CONTRACT No. 1800

WET WEATHER PUMP STATION

ADDENDUM No. 2

WET WEATHER PUMP STATION PROJECT

MOTOR FLOOR PLAN

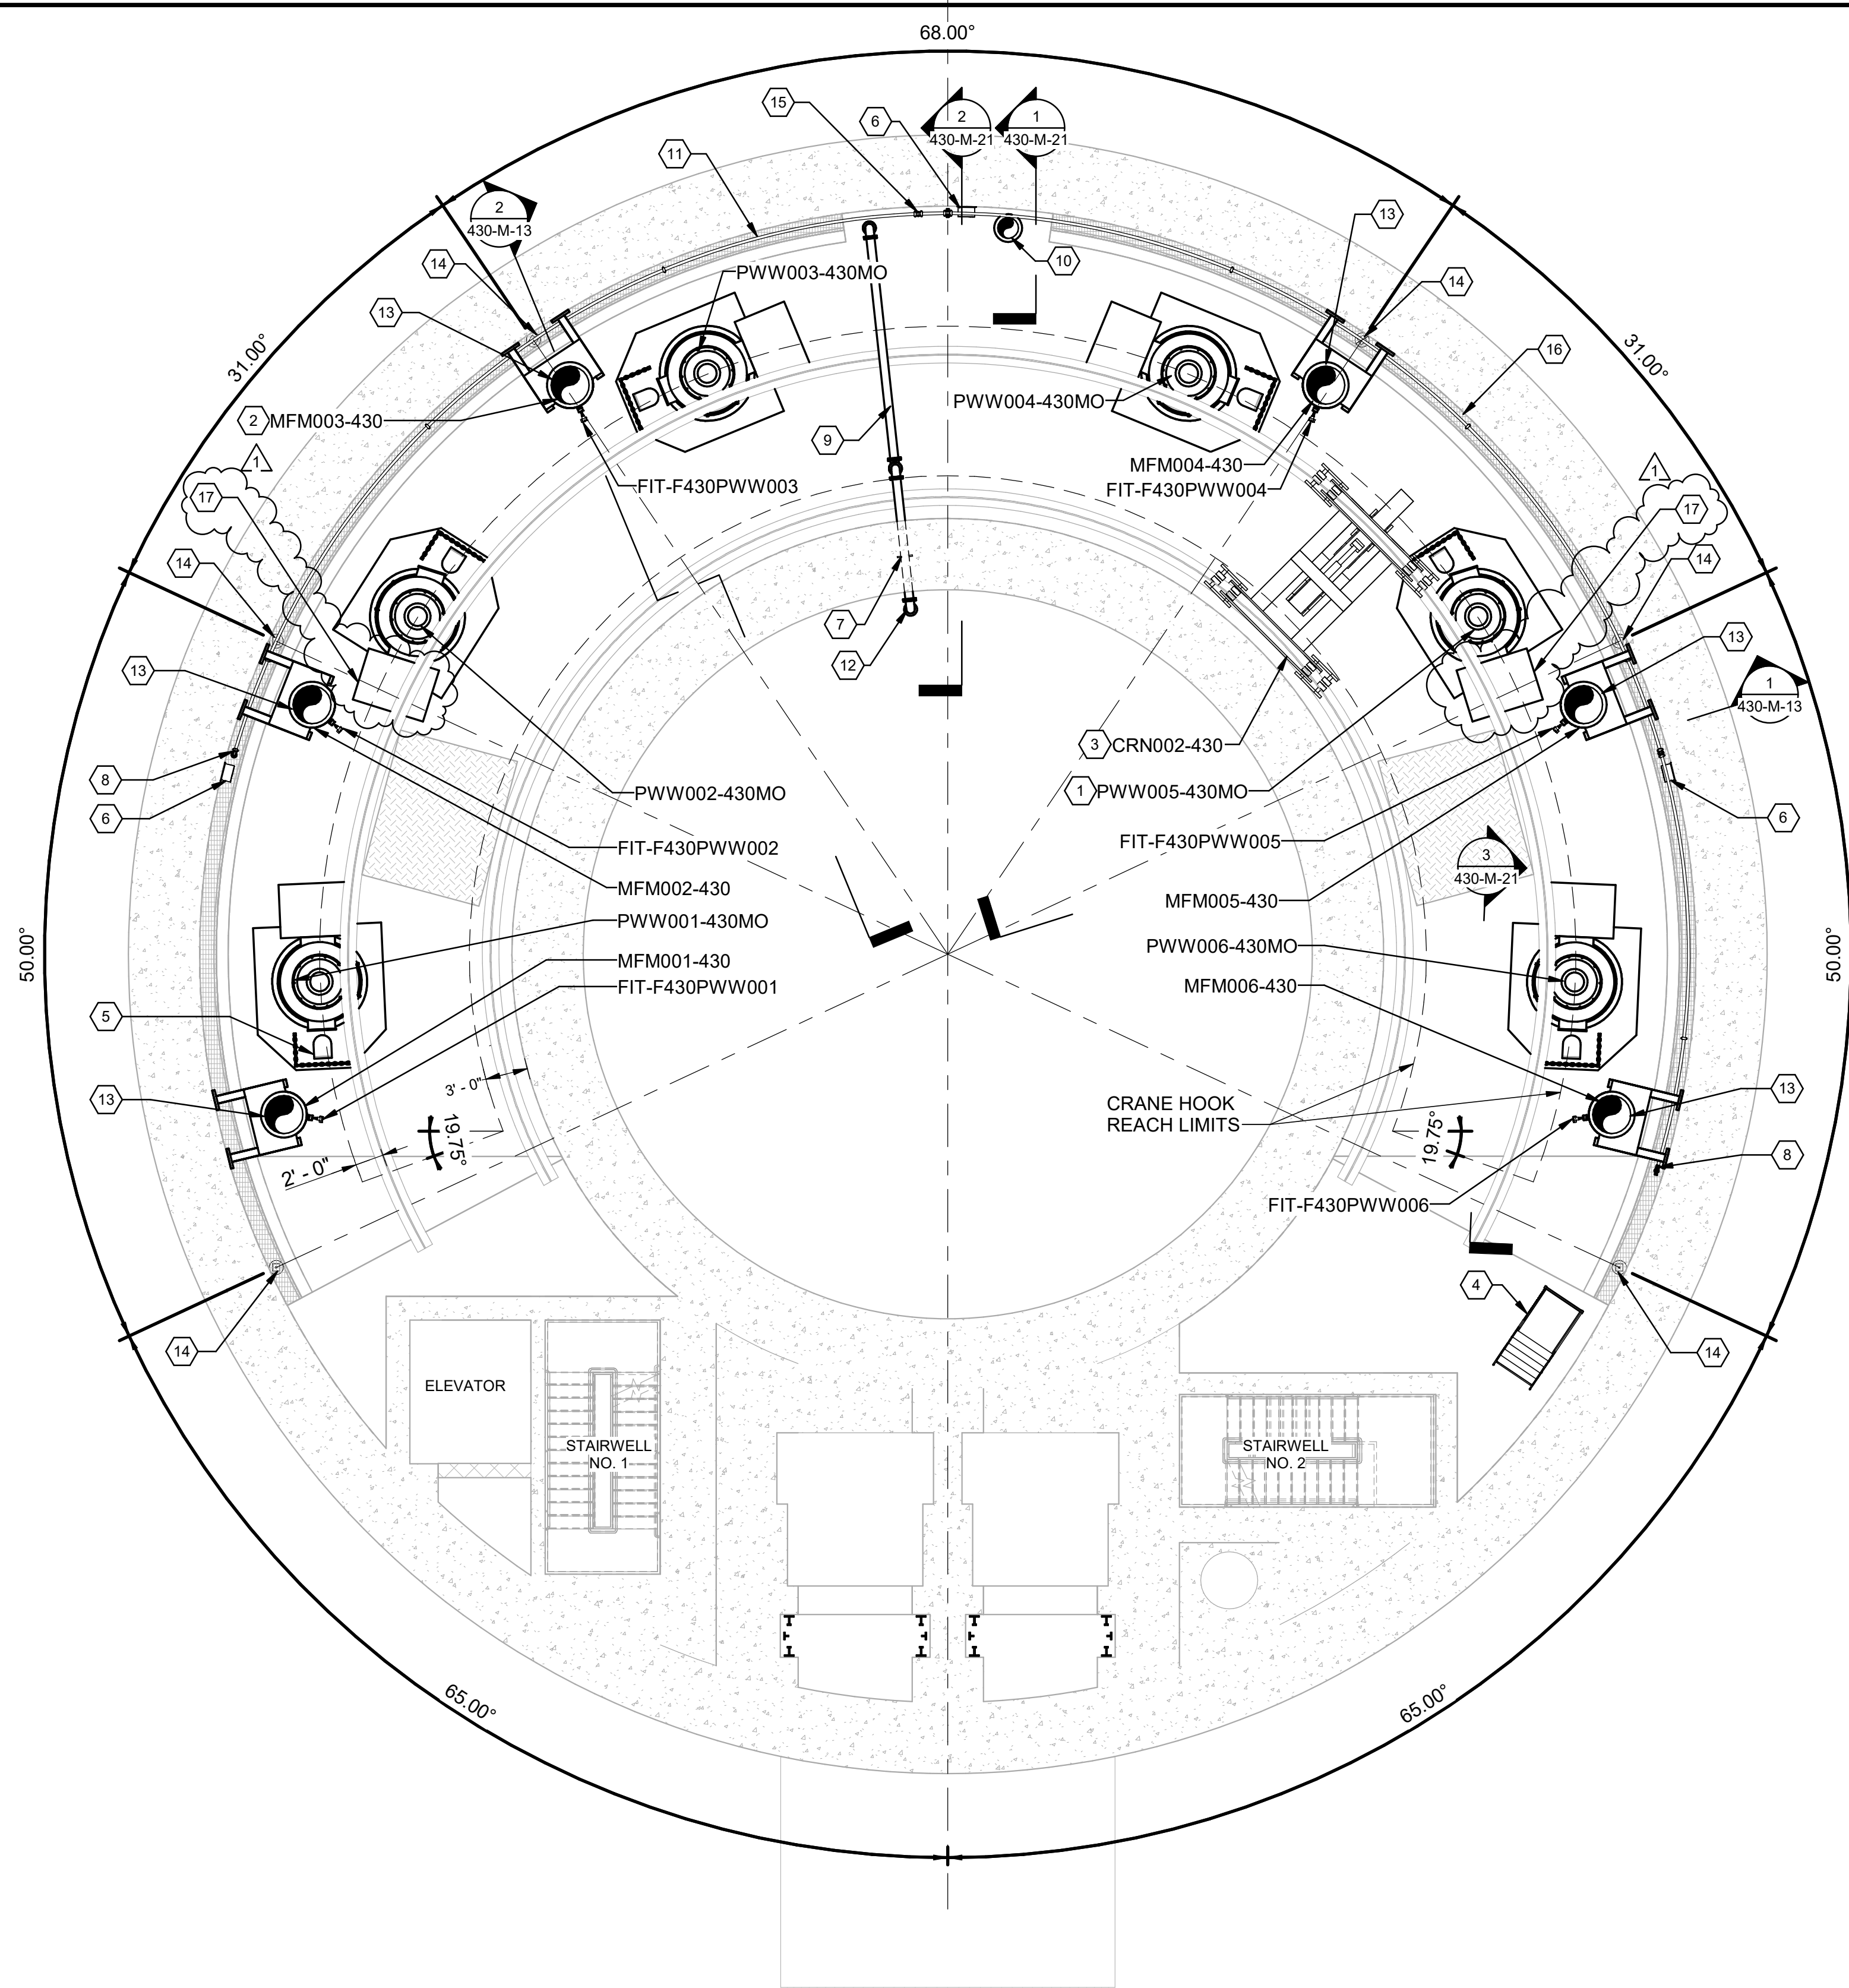
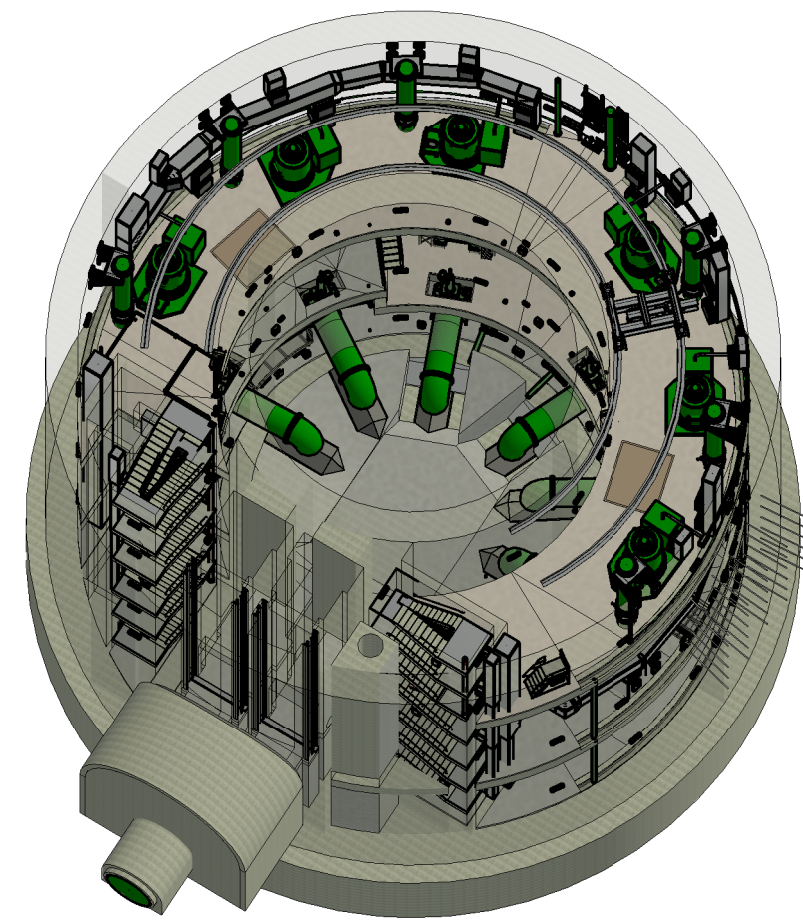
- 3.1 On Sheet 000-C-23, **ADD** trees at new locations. **REPLACE** Sheet 000-C-23 with Sheet 000-C-23 Rev. 01, refer to Attachment C.
- 3.2 On Sheet 430-M-03, **UPDATE** orientation of motor terminal enclosures. **REPLACE** Sheet 430-M-03 with Sheet 430-M-03 Rev. 01, refer to Attachment C.
- 3.3 On Sheet 430-ET-03, **UPDATE** orientation of motor terminal enclosures and power connection. **REPLACE** Sheet 430-ET-03 with Sheet 430-ET-03 Rev. 01, refer to Attachment C.
- 3.4 On Sheet 000-ESP-04, **UPDATE** size of manhole EMH-224. **REPLACE** Sheet 000-ESP-04 with Sheet 000-ESP-04 Rev. 01, Refer to Attachment C.
- 3.5 On Sheet 430-ED-03, **UPDATE** Details 1 and 2. **REPLACE** Sheet 430-ED-03 with Sheet 430-ED-03 Rev. 01, refer to Attachment C.

1 TYPICAL MANHOLE (WITH GROUNDING)

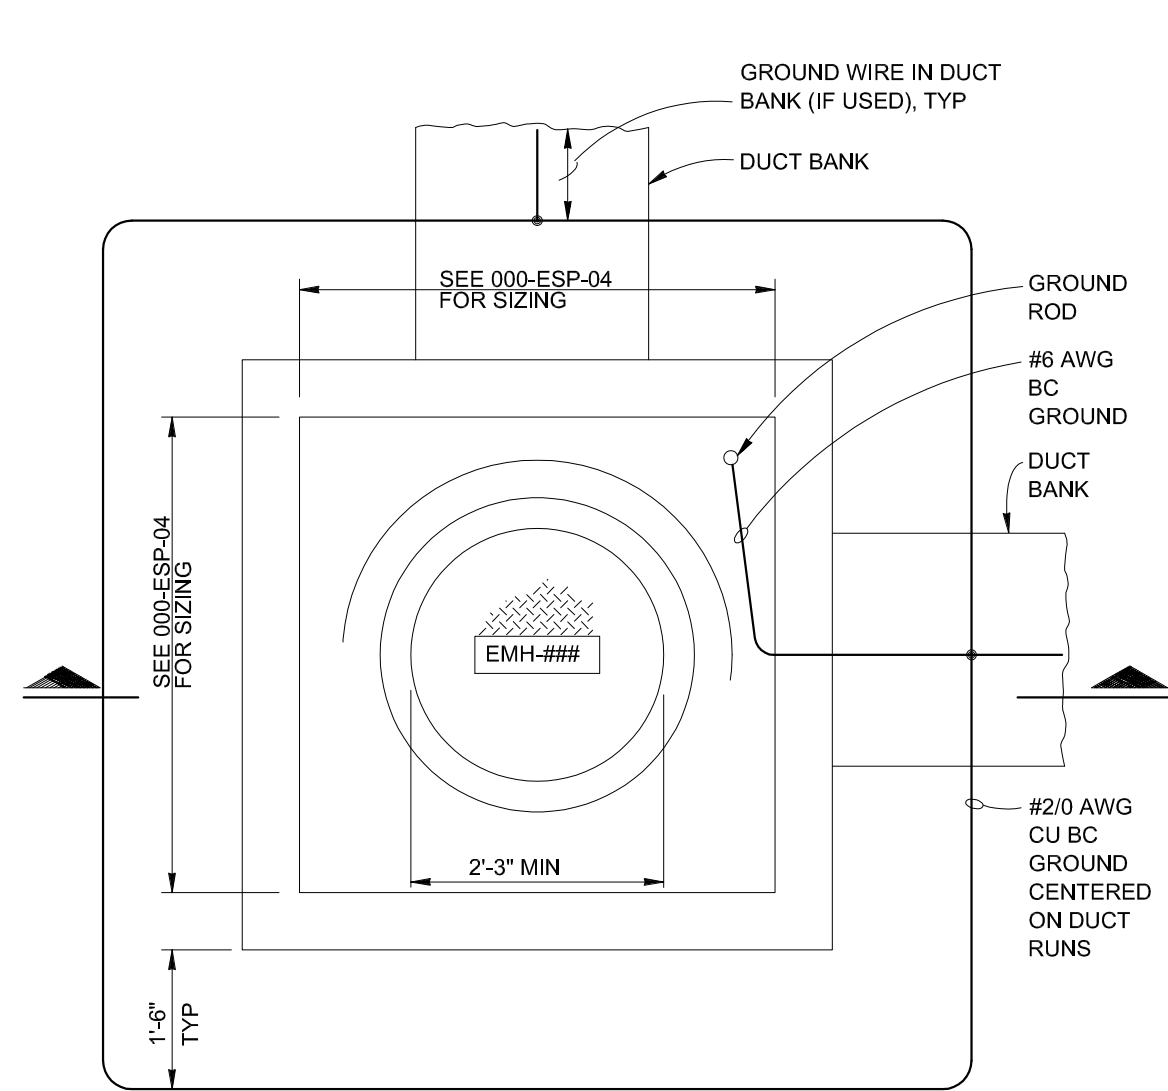
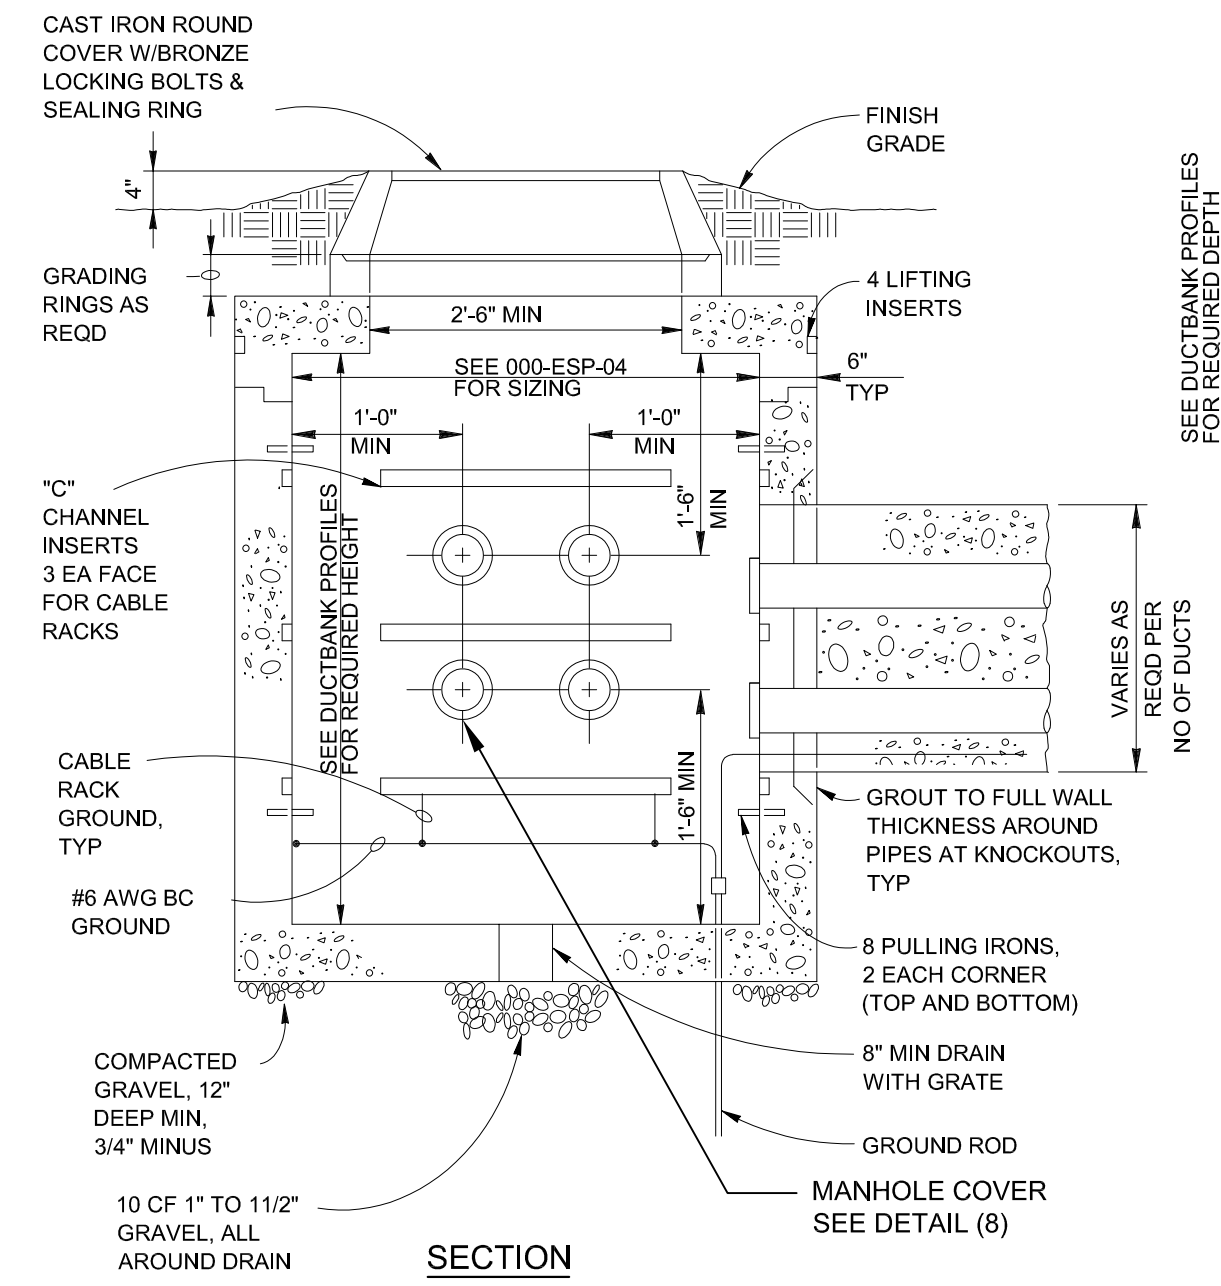
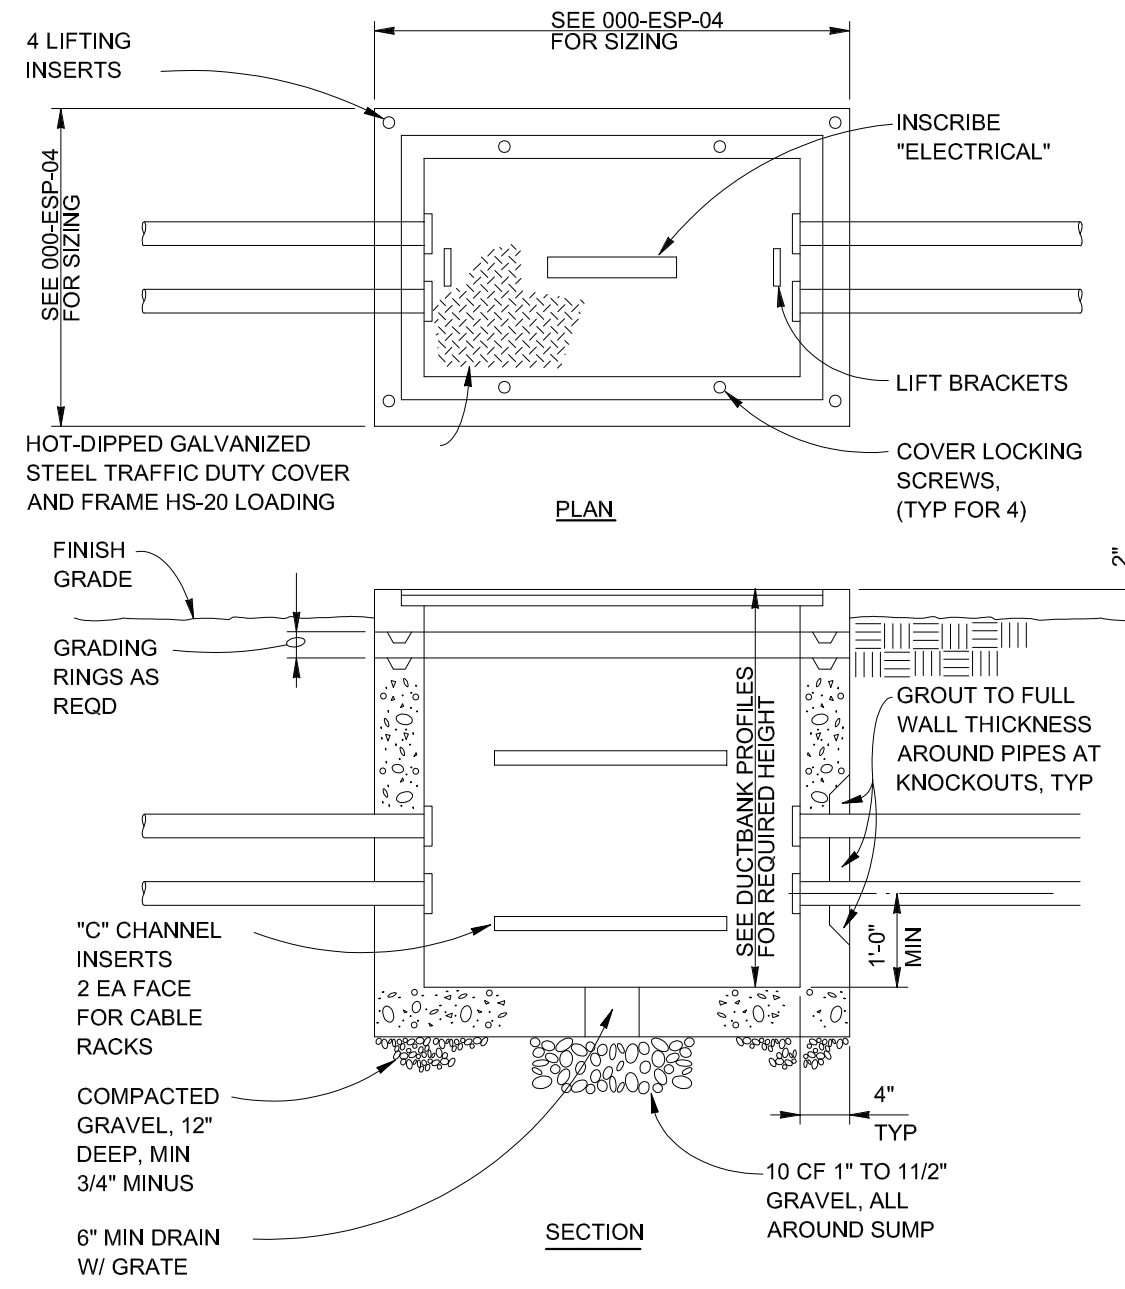
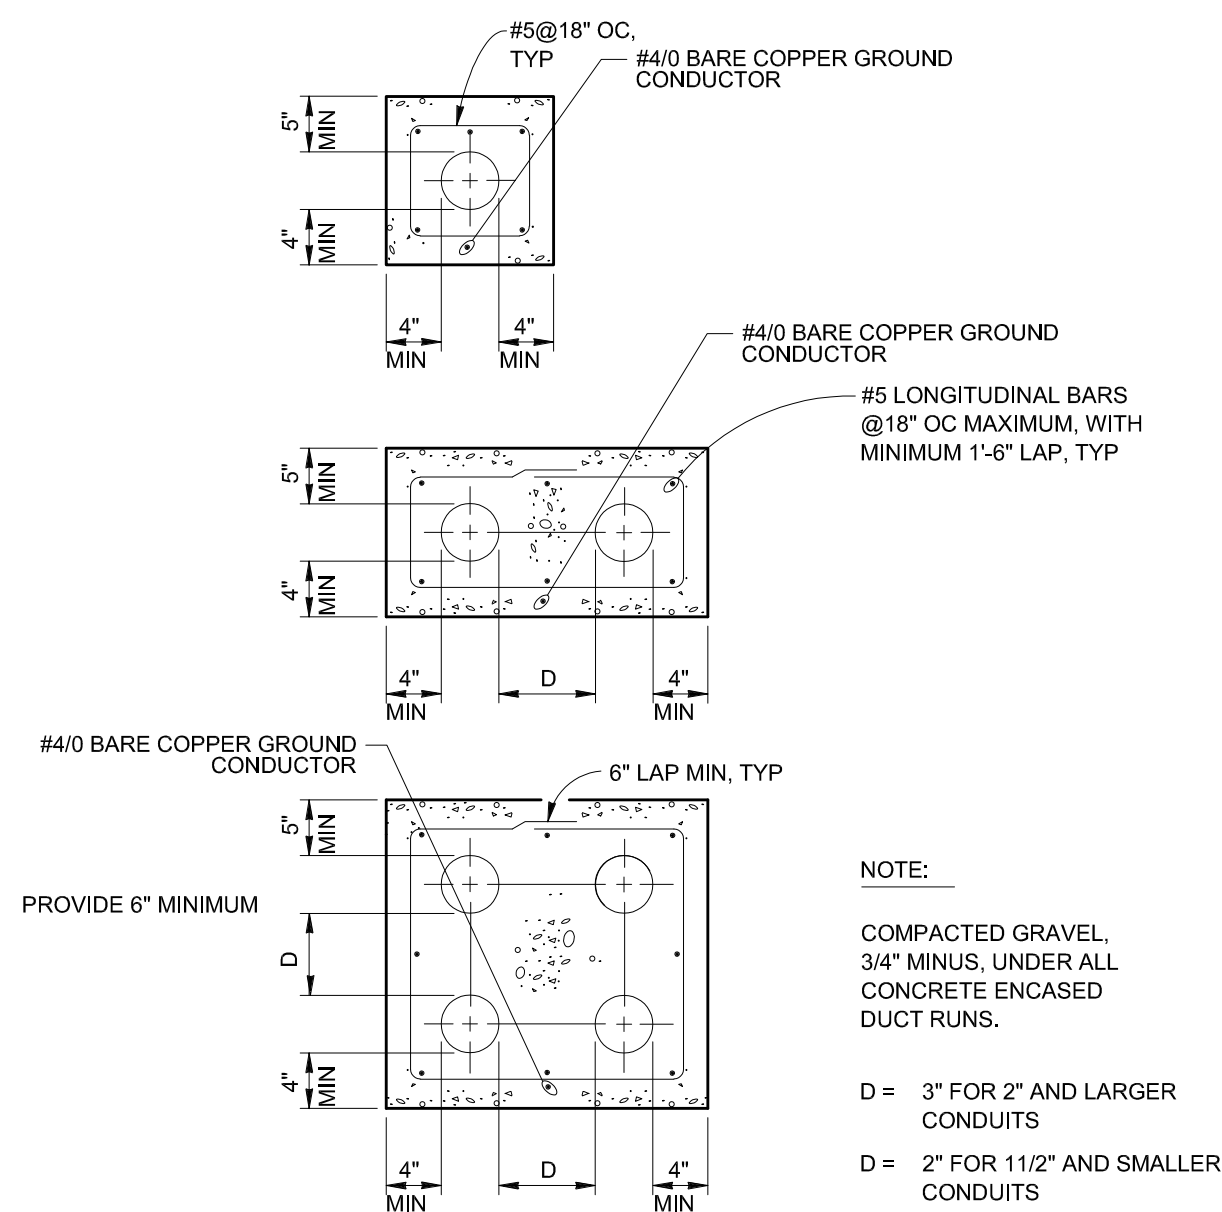
- Q1:** Since no Manhole or Handhole sizing details have been provided on Drawing 430-ED-03 and Specification Section 33.05 13.16 can dimensional sizes for the pre-cast manholes and handholes that are required to be provided by the 1800-E Contractor be provided?

- A1:** Precast manholes are shown on drawing 000-ESP-04 as 4' and 8' square. Typical Manhole and Handhole details are shown on 430-ED-03. See specification 26 05 33 for manhole and handhole requirements.
